Ageas Bowl, Hampshire

Flood and Drainage Addendum

The LLFA are Hampshire County Council (HCC) and provided comment on the FRA dated October 2022, requesting the provision of some additional information and clarification of certain points.

Figure 1 – Telegraph Brook lower Section and Lakes

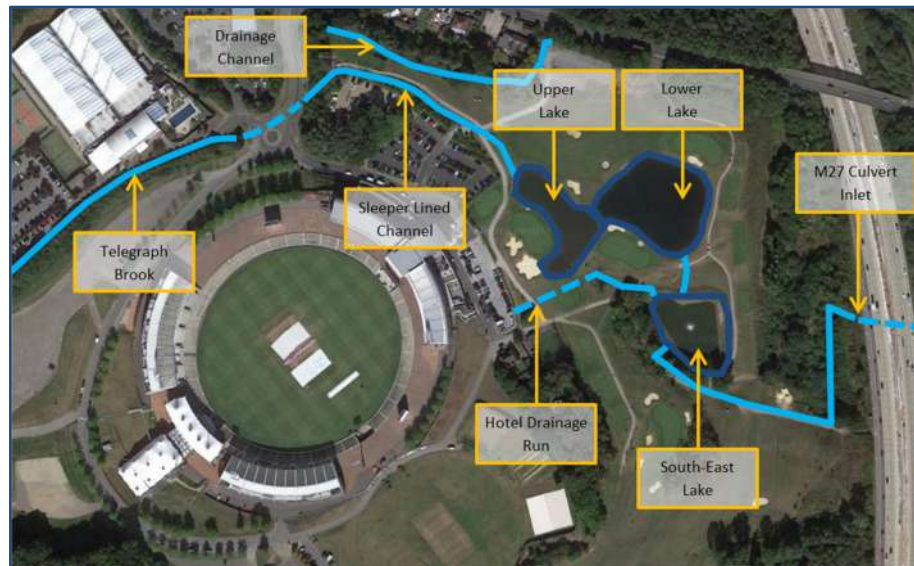
“It is difficult to see the current ditch location and extents. Can this be highlighted better on plans along with onward connectivity.”

The line type used on the drainage plan has been amended as requested to make them clearer. The existing drainage plans highlighting the current ditch are provided as **Appendix B**.

The drainage through and from the site is explained in paragraphs 3.36 to 3.43 of the FRA and also with Figure 3.5 in the FRA showing the drainage features (included below as **Figure 1**) and summarised as:

Figure 2 – Plan showing the Flood Modelling Node Locations for the Flood Levels

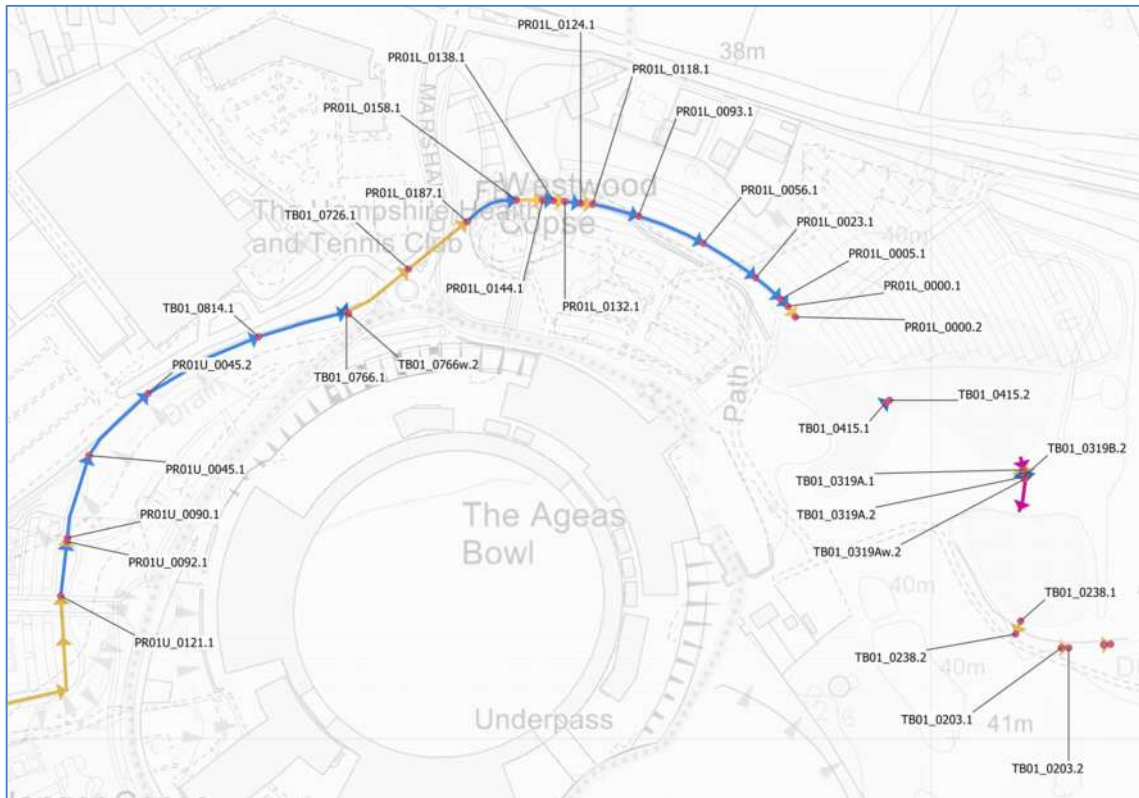
“The concept of de-culverting with 2 stage channel is supported but will require consent separately from the planning process. It is advised that a pre-app discussion is undertaken with the OWC team as this is fundamental to the planning proposals.”

The FRA included a summary of the baseline flood modelling study completed of the existing watercourse. It advised that the post-development flood modelling of the alterations proposed to the watercourse and lakes was not available at the time of writing. The post-development flood modelling has since been completed, and the summary note from Thomas Mackay is included as **Appendix D**.

Figure 2 below shows the node locations along the channel where flood level information has been provided by the flood model, with these flood levels for key return period events given in **Appendix D**.

The flood modelling node locations through the car park are between PR01L_0144.1 and PR01L_0005.1. Based on the post-development flood modelling, the required level of the channel top of bank as it passes through the car park in order to prevent channel overtopping are summarised in **Table 1**.

Although not a detailed design, the flood levels for the 1% AEP + 51% glass-walled scenario in the upper reach of Telegraph Brook as it passes through the residential area lower than the bank top elevations. In the lower reach of Telegraph Brook as it passes through the car park, the flood levels suggest that the bank top elevations would need to be elevated by approximately 0.2m to 0.3m and with an appropriate freeboard allowance to prevent channel overtopping.
